City of Santa Barbara
Planning Division

Memorandum

SUBJECT: Staff Evaluation of proposed alterations

ADDRESS: 219 West Arrellaga Street designed by 1903

1930 Sanborn Map, illustrating the porch on the building

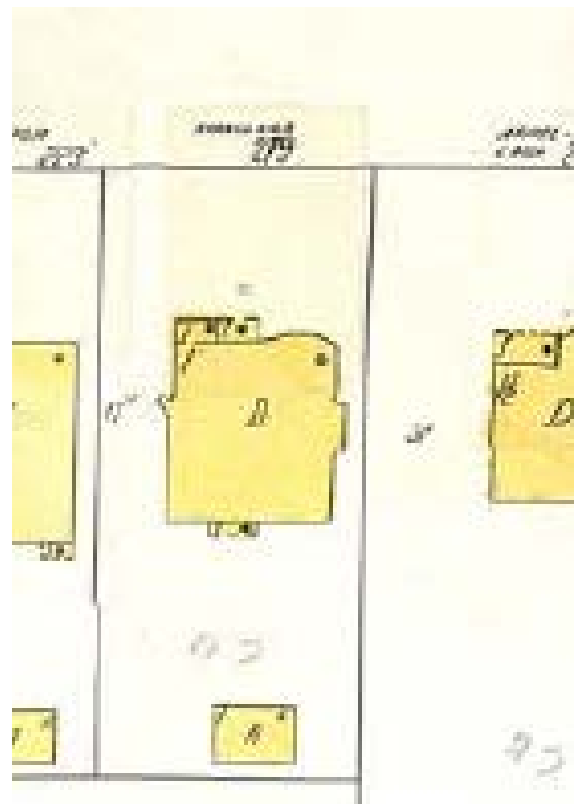
The house had a front porch that is substantiated by the 1930 Sanborn map. The porch was removed at an unknown date. The new porch will be simple in style to be compatible to the Folk Victorian style so that it will restore integrity the historic resource.

The project meets Standard 9 as the addition of the front porch is actually returning a character defining feature of the house to the façade. The porch will be simple in style to be compatible with the house.
